Erratum: "Potential Load Reduction Using Airfoils with Variable Trailing Edge Geometry" [Journal of Solar Energy Engineering, 2005, 127(4), pp. 503–516]

Thomas Buhl, Mac Gaunaa, and Christian Bak

Fig. 5 Inflow setup. The $y=0$ plane corresponds to the rotor plane. U corresponds to the rotational velocity, while $V(t)$ corresponds to the free-stream velocity.

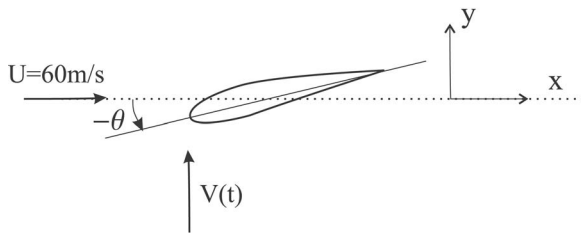
Figures 5–7 were not correct in the published article. See below for the correct figures.
